GRANDVIEW SCHOOL DISTRICT NO. 200
DISTRICT FENCING PROJECT 2013
GRANDVIEW, WA 98930

ADDENDUM NO. 1

August 14, 2013

SEF-SP

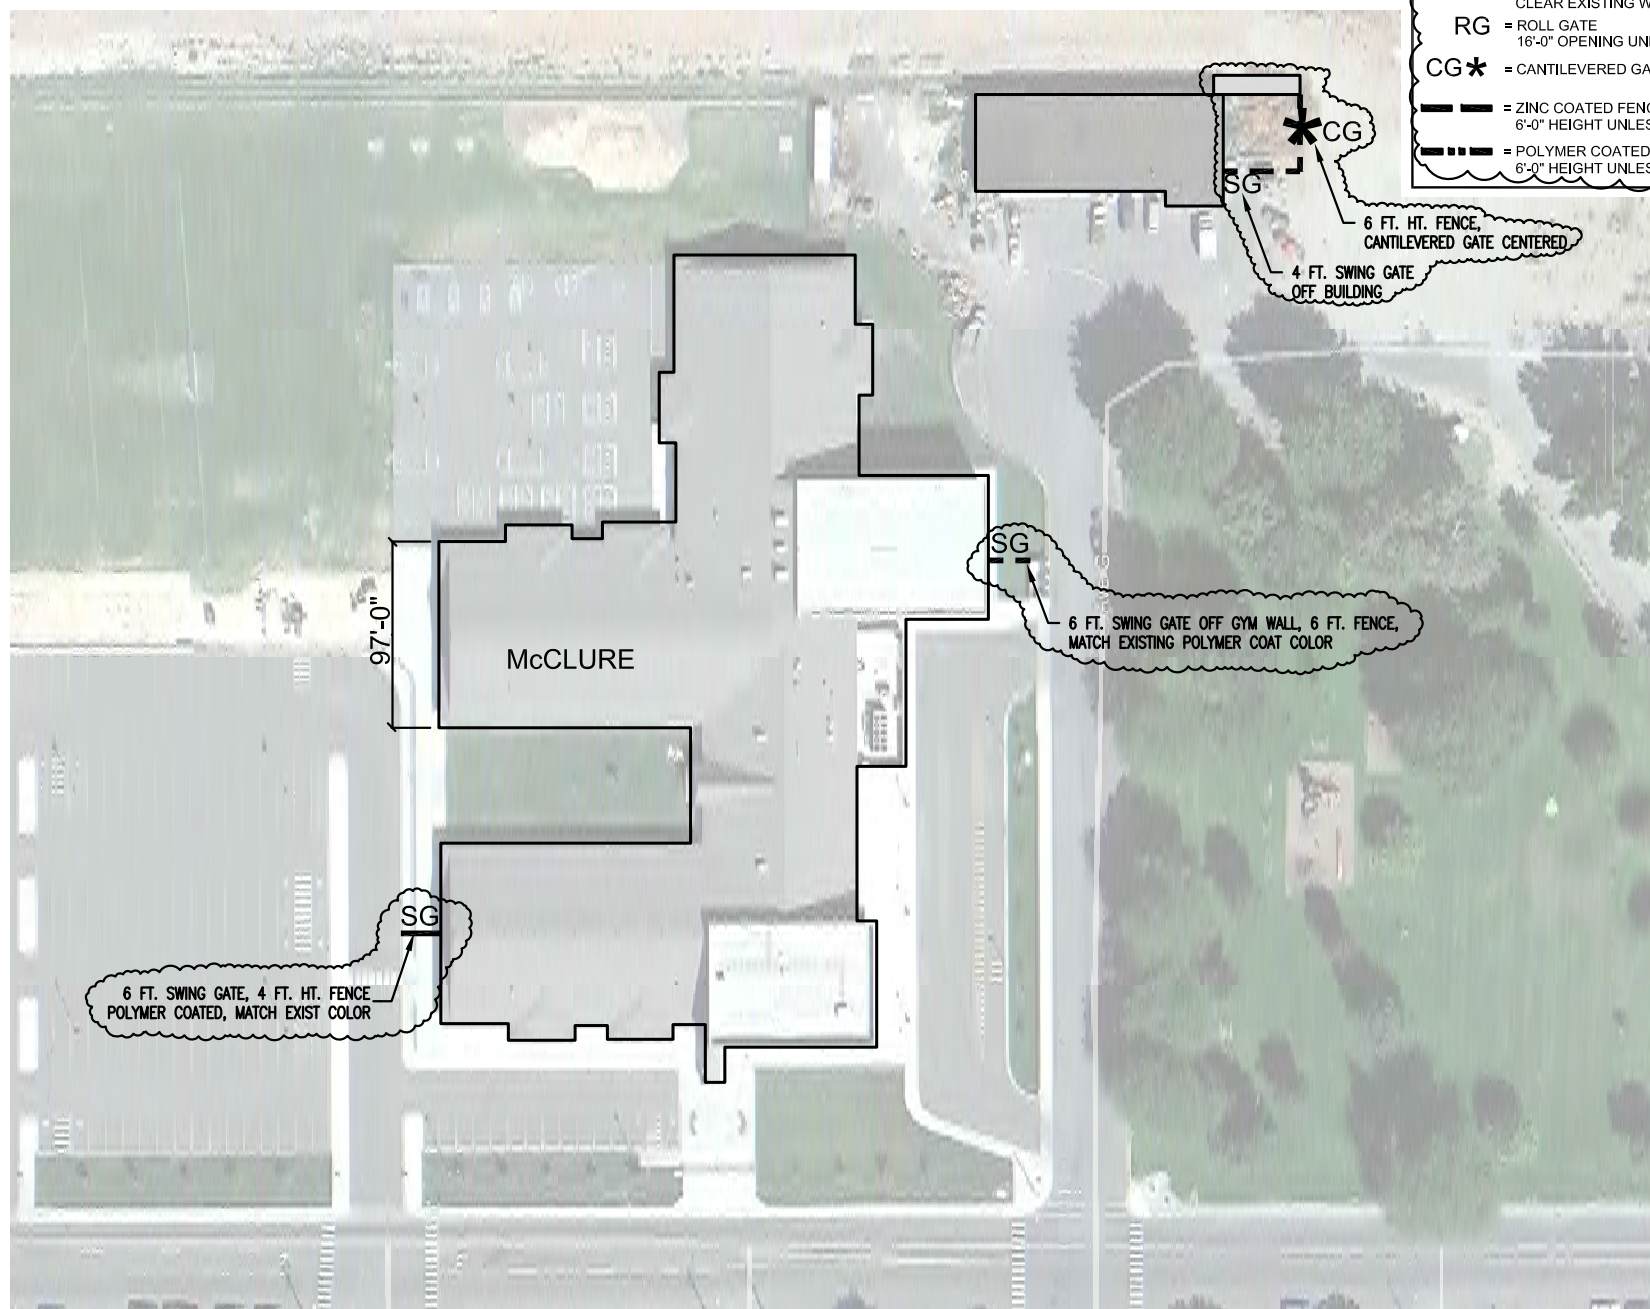
- XI. Question: Are the roll gates to be “roll gates” or “cantilevered gates”? Answer: Roll gates designated on drawings are to be cantilevered gates, unless specifically noted as “roll gate”. See addendum revised drawings for clarification.
